Commercial Plans
RECEIVED
1/16/2026
DEPARTMENT OF
ENGINEERING
ENGINEERING
REVIEW COPY

SHEET TITLE: GENERAL INFORMATION SHEET			
		DRAWING NUMBER: G002			
NEW FIRE STATION #10 ST. TAMMANY FIRE PROTECTION DISTRICT NO. 1 2745 LAKESHORE VISTA BLVD SLIDELL, LA 70461		JOB NO: 2519	DATE: 12-03-2025	DRAWN BY: GSD	CHECKED BY: JMS
This drawing was prepared and issued under the supervision of the Professional Engineer named herein, who is duly licensed by the State of Louisiana. The Engineer's name and license number are shown on the drawing. The Engineer is responsible for the design and construction of the project. The Engineer is not responsible for the construction of the project. The Engineer is not responsible for the construction of the project. The Engineer is not responsible for the construction of the project.		This drawing was prepared and issued under the supervision of the Professional Engineer named herein, who is duly licensed by the State of Louisiana. The Engineer's name and license number are shown on the drawing. The Engineer is responsible for the design and construction of the project. The Engineer is not responsible for the construction of the project. The Engineer is n

SHEET TITLE:
SITE PLAN - EROSION
CONTROL AND DETAILS

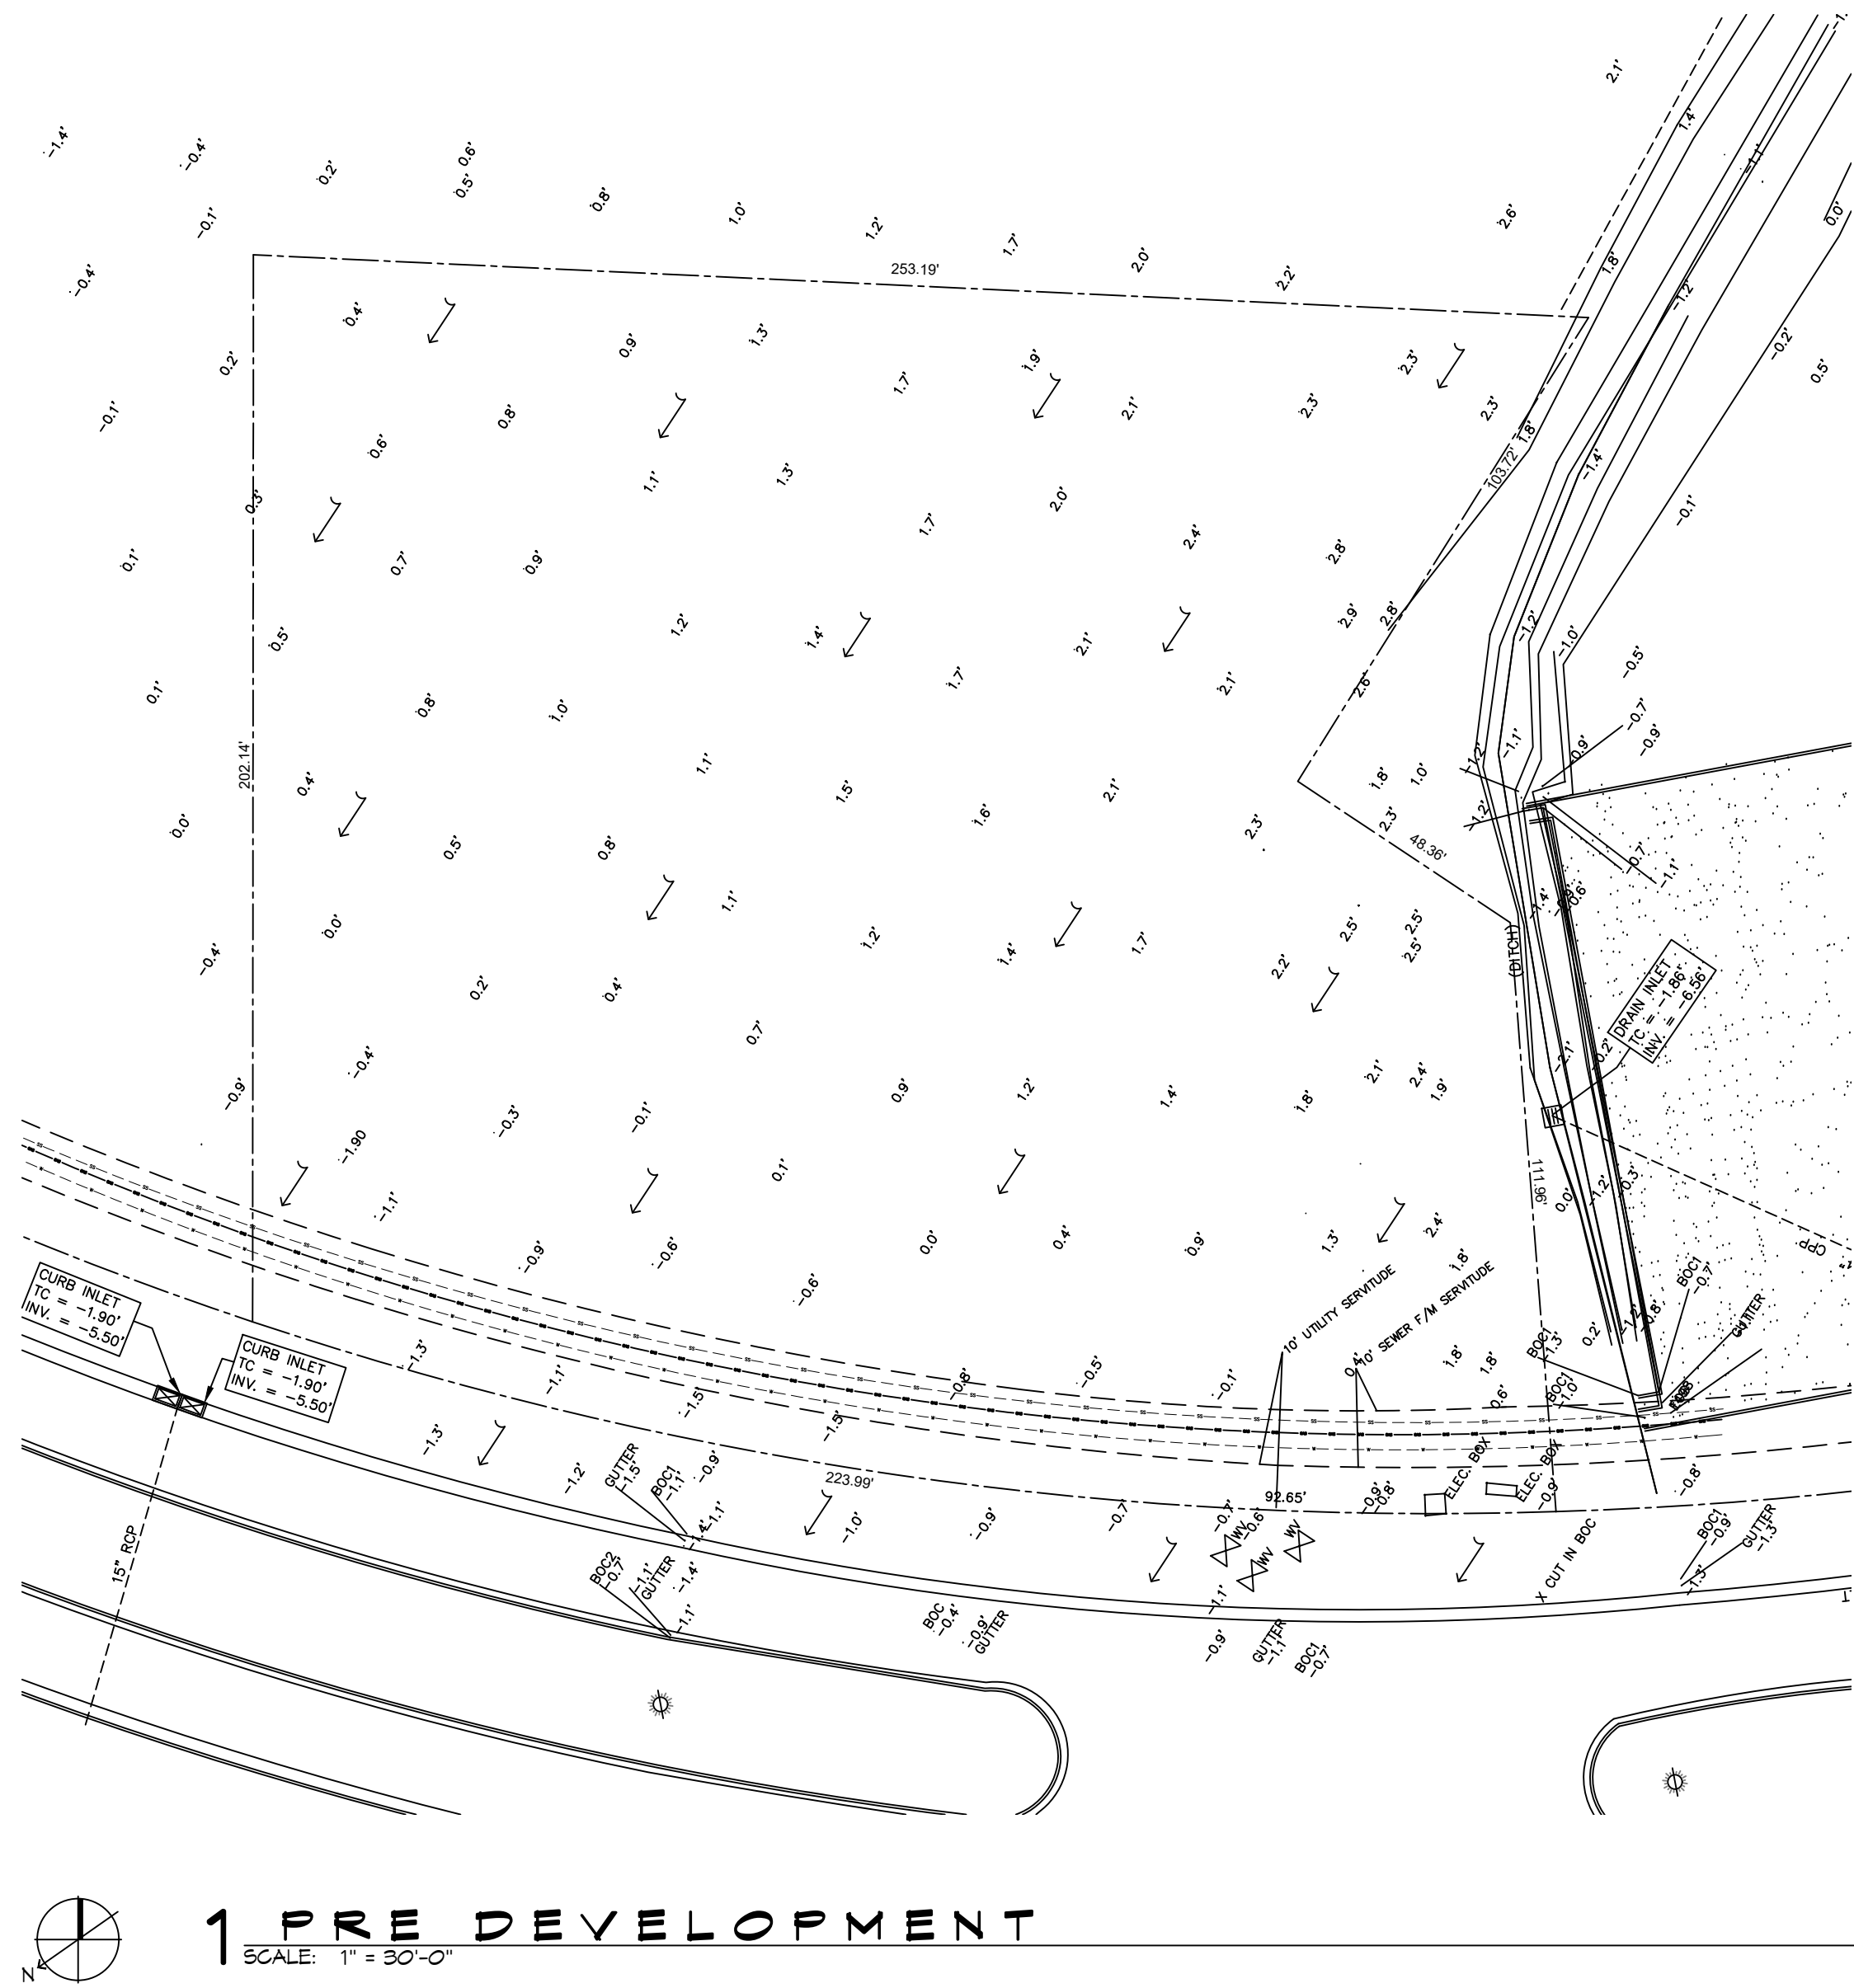
Provide construction detail and/or notes for required 6" depth for temporary construction entrance.

LANDSCAPE PLANTING PLAN

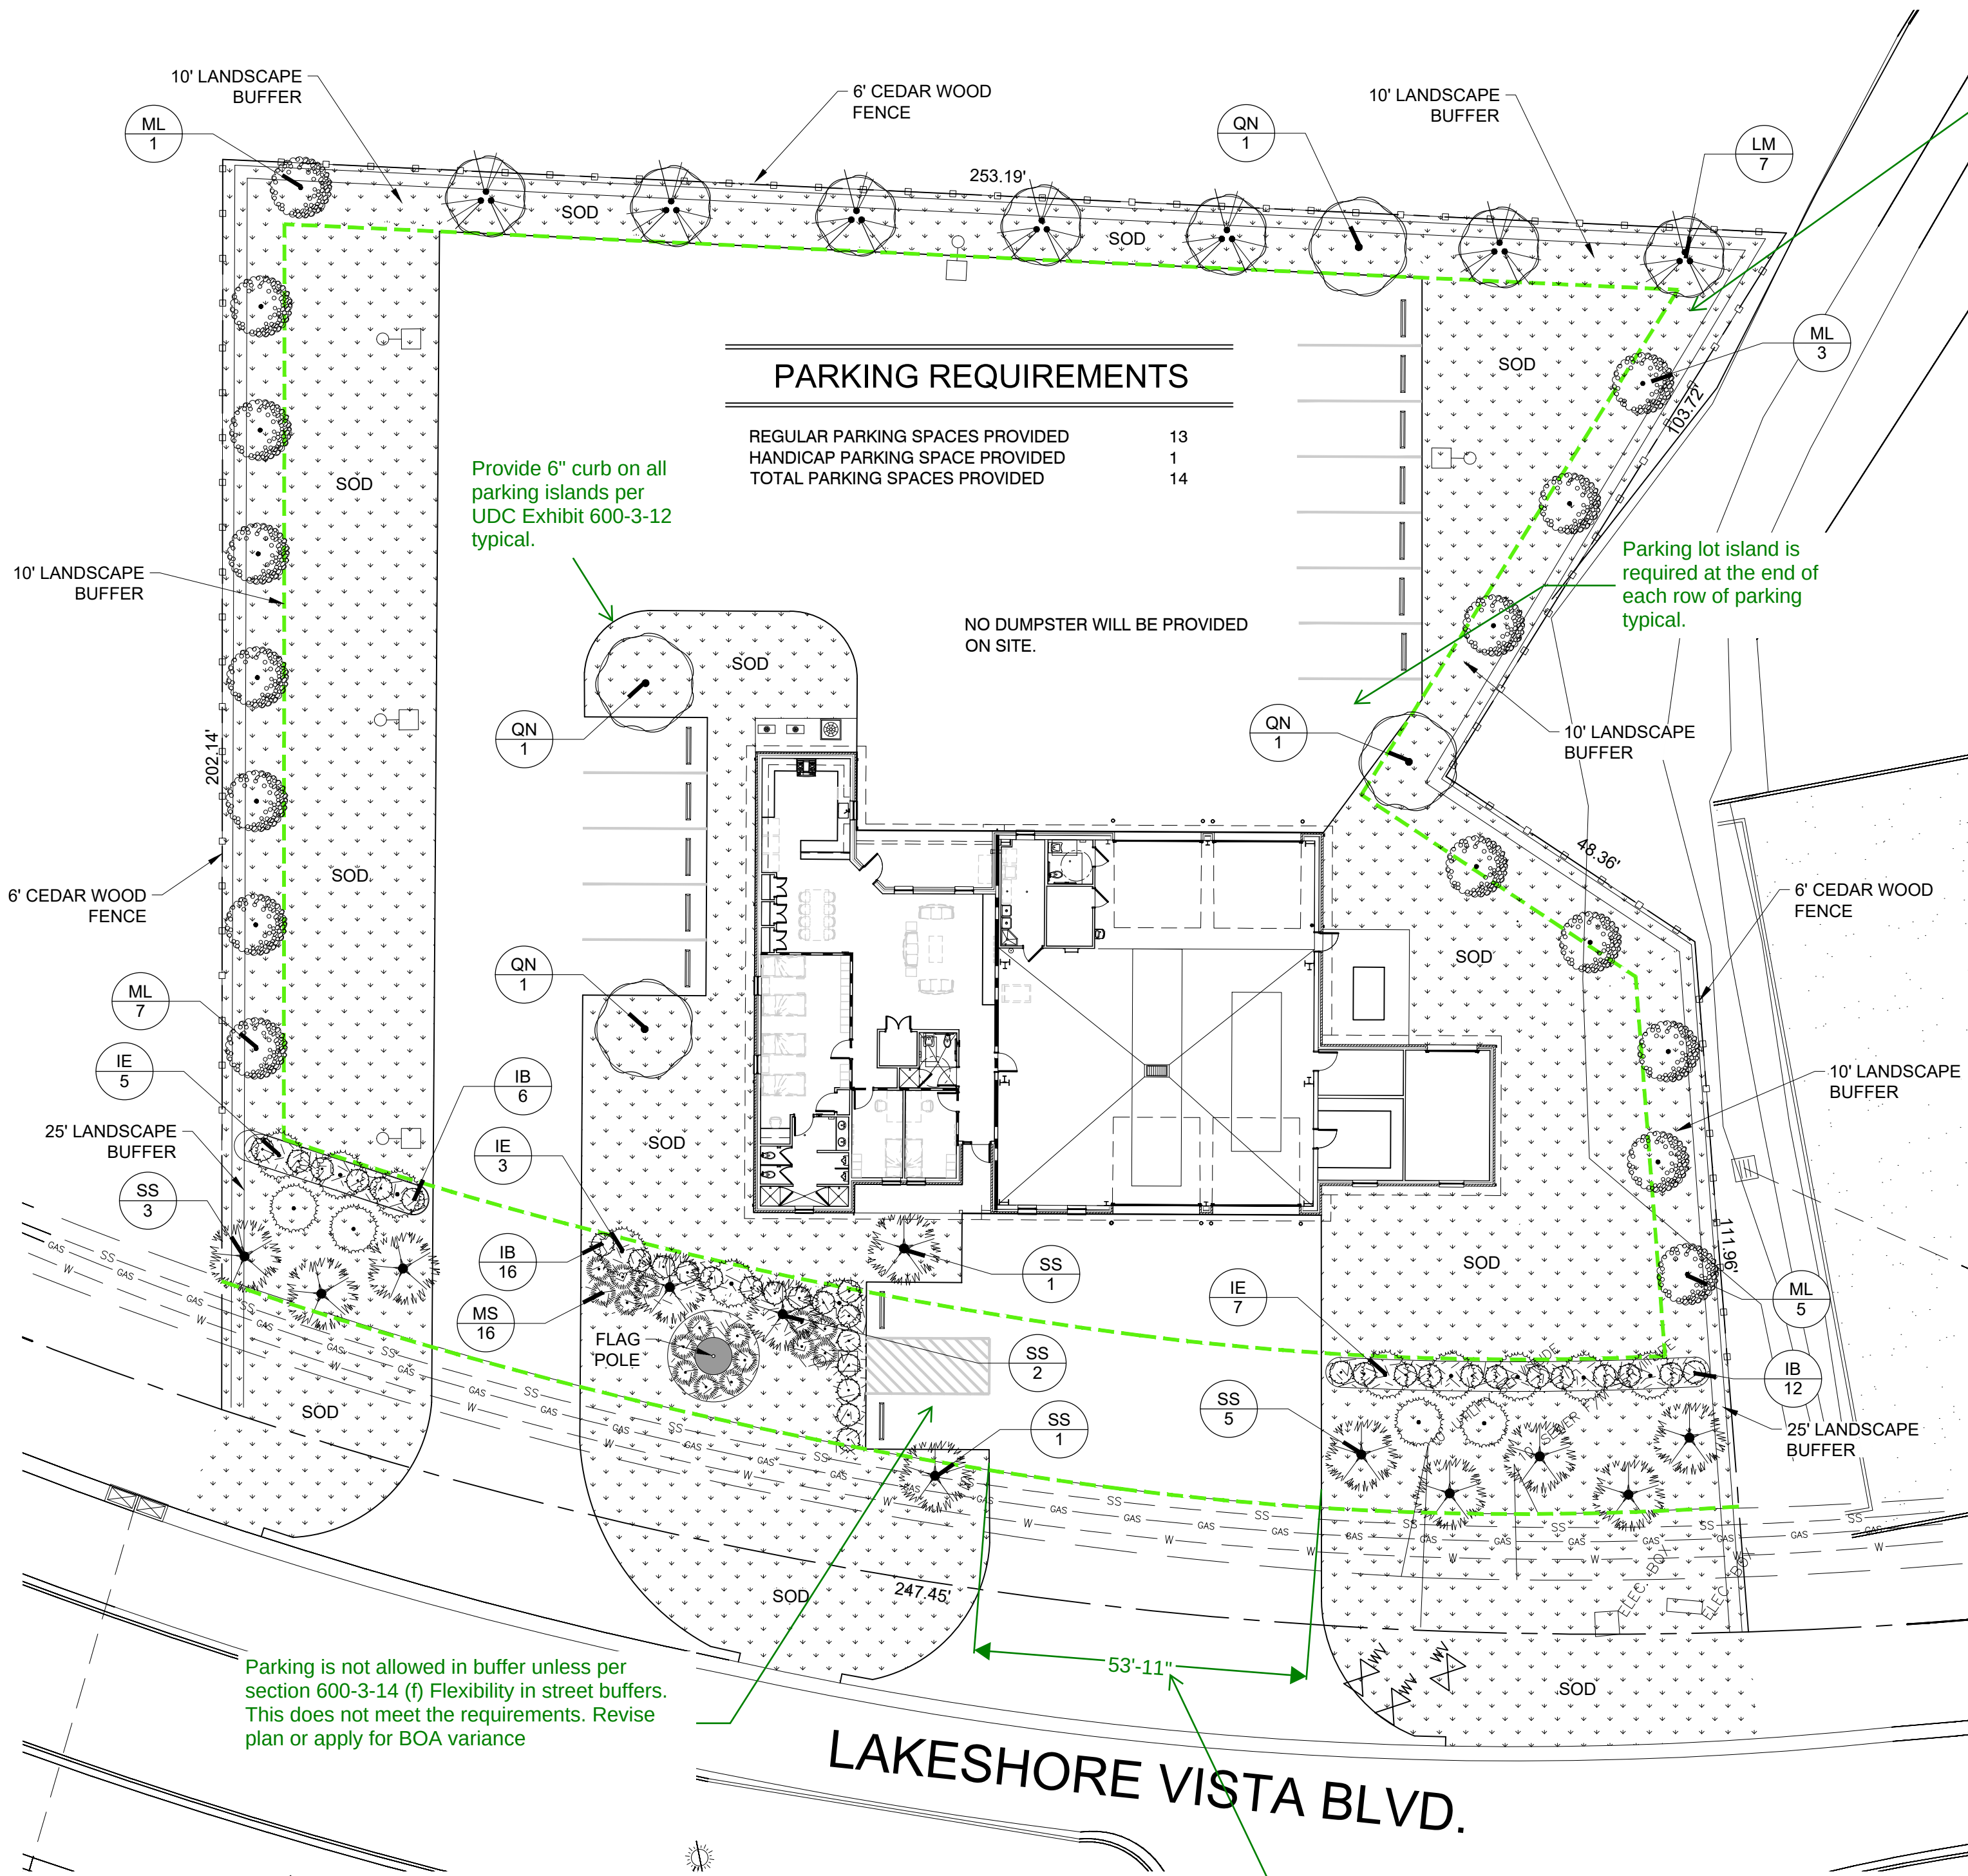
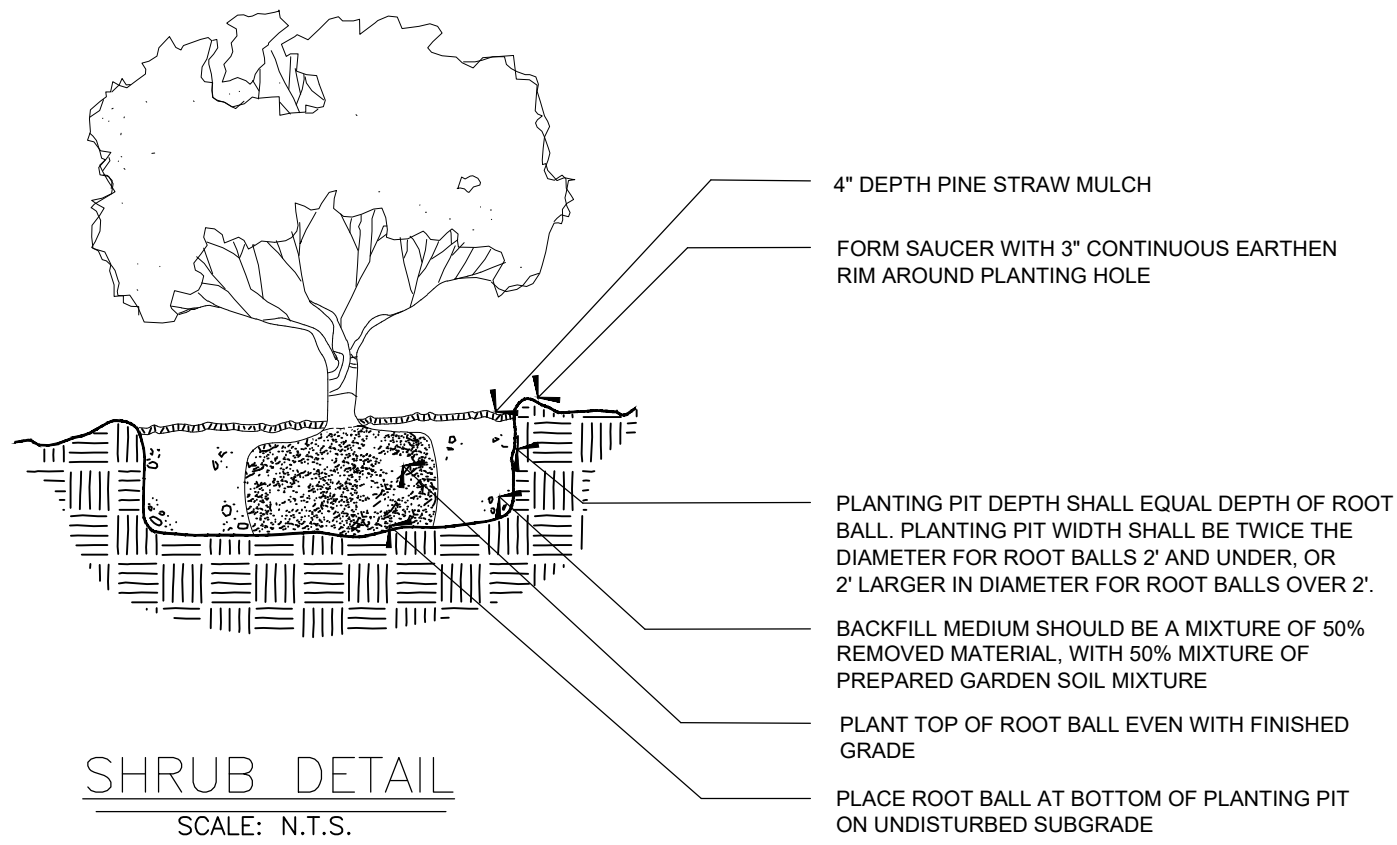
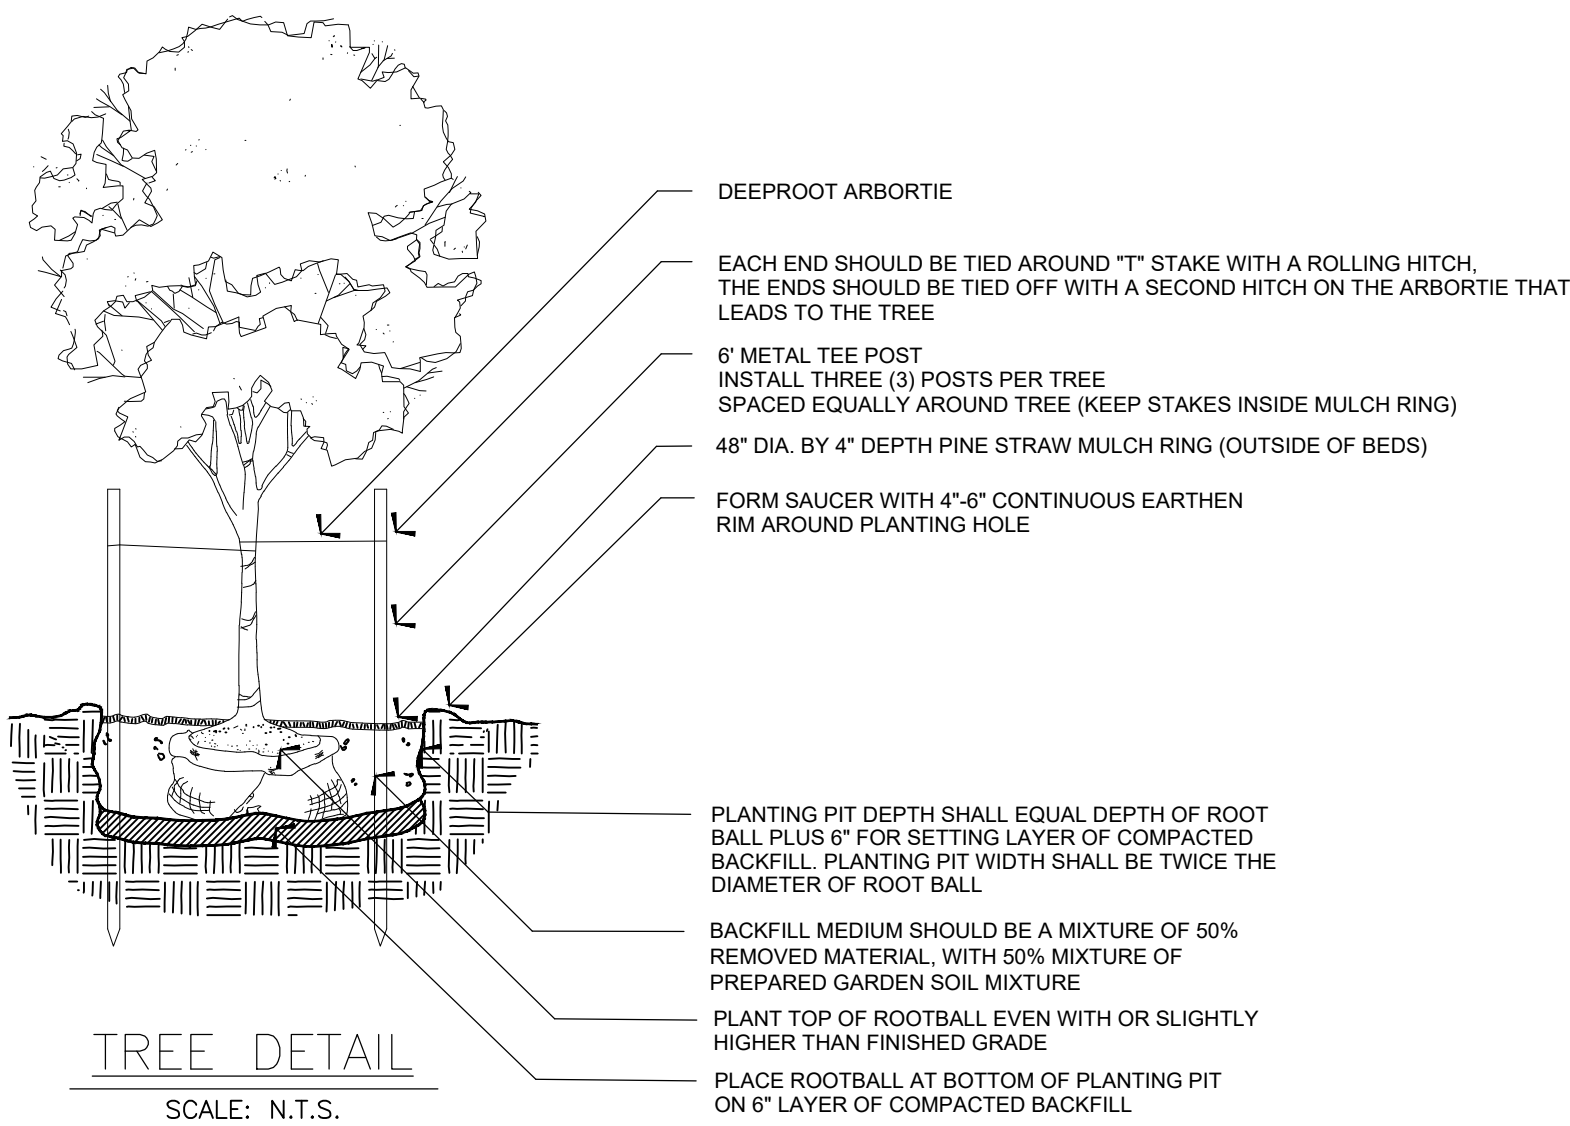
Provide 6" curb on all parking islands per UDC Exhibit 600-3-12 typical.

Parking is not allowed in buffer unless per section 600-3-14 (f) Flexibility in street buffers. This does not meet the requirements. Revise plan or apply for BOA variance

Per UDC Sec 600-5-2 Driveway Requirements, the maximum driveway width through a buffer is 35'. Revise or apply for variance from BOA.

Landscape Plan shall identify pervious/impervious areas to comply with Sec 600-3.4 (D)(1). Provide min. 30% pervious area.

Signage is by separate permit and must comply with UDC Section 600-4.3 Sign Standards

Coordinate utilities, civil and landscape package to avoid conflicts with existing and proposed trees per code. Typical. Specifically, review drainage and grading to ensure no cut or fill in buffers or below drip line of protected trees.

Indicate the building square footage and use of all structures typical.

Parking islands must meet requirements of Unified Development Code Chapter 600-5.1 Parking Requirements. Provide 9x18' islands with Class 'A' tree and living ground cover and 6" curb at the end of each row of parking. Island required at the end of each row and max 12 spaces between islands.

Dimension all buffers, driveways, drive aisles, islands and typical parking spaces.

Indicate zoning of site on plan. LV-3 as Lakeshore Estates PUD.

Indicate on plans if any variance was granted by BOA and note any items approved on the plan.

Civil plans show swales on 3 sides in the landscape buffer. Landscape buffer must be provided outside of any servitudes or drainage easements. Move buffer inward to provide required planting area as needed or relocate swales outside of buffers.

Add Note to plan that surrounding property is zoned LV-3 per teh Lakeshore Estates PUD. Proposed future use will be public or commercial use such as soccer fields.
